**HIROSE ELECTRIC CO., LTD.**  
2-6-3 Nakagawa Chuoh, Tsuzuki-ku, Yokohama, JAPAN

### Product Change Notification

## ■Product List PCN2020-24\_【Revised&amp;Reissued】EF2-D30, D60 Product specification change

■ Changes PCN2020-24\_【Revised&Reissued】EF2-D30, D60 Product specification change

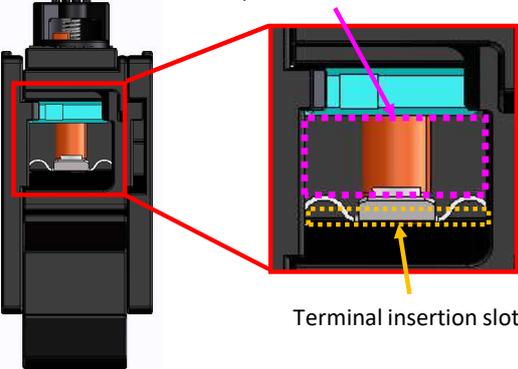
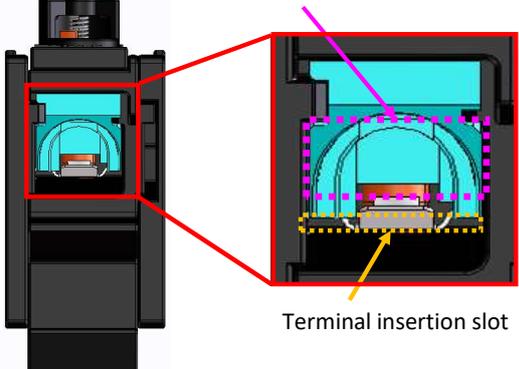
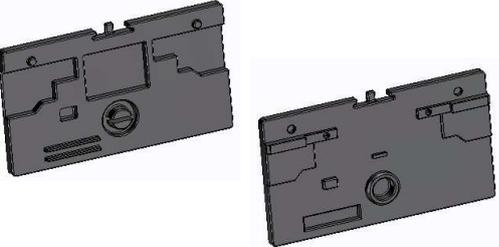
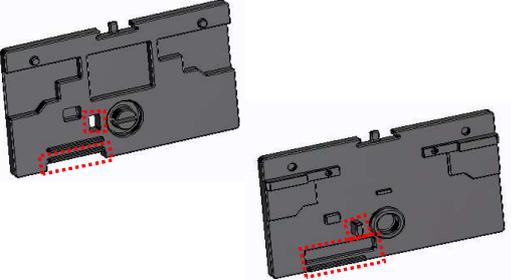
【Current product】	【Replacement product】
Housing

Lock plate

<p data-bbox="363 1088 724 1115">There is space for terminal to enter</p>  <p data-bbox="507 1413 738 1440">Terminal insertion slot</p>	<p data-bbox="906 1088 1299 1115">There is no space for terminal to enter.</p>  <p data-bbox="1098 1413 1329 1440">Terminal insertion slot</p>
End plate * Only for EF2-D30-1, EF2-D60-1

<p data-bbox="196 2007 411 2040">  ...Changes         </p> <p data-bbox="204 2051 858 2078">These changes will not affect the performances of the product.</p>
